Service Bulletin

Eligibility of GA8 aircraft for United Kingdom (UK) CAA certification.

Document: Service Bulletin SB-GA8-2005-17

Figure 1 – Tachometer marking

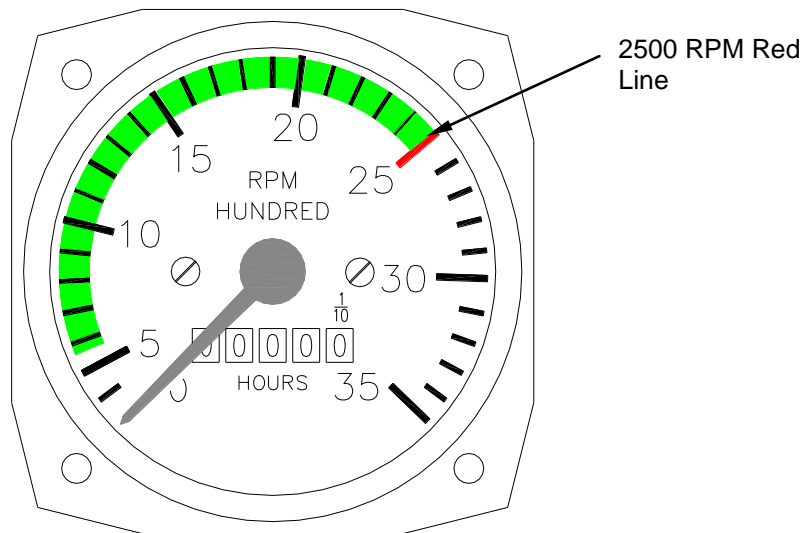
Alternatively, the existing tachometer P/N GA8-771013-11 may be reworked by re-marking the dial. Remove the existing red arc between 2500 rpm and 2700 rpm. Mark a red line at 2500 rpm. Refer to Figure 1. Re-identify the tachometer as GA8-771013-13.
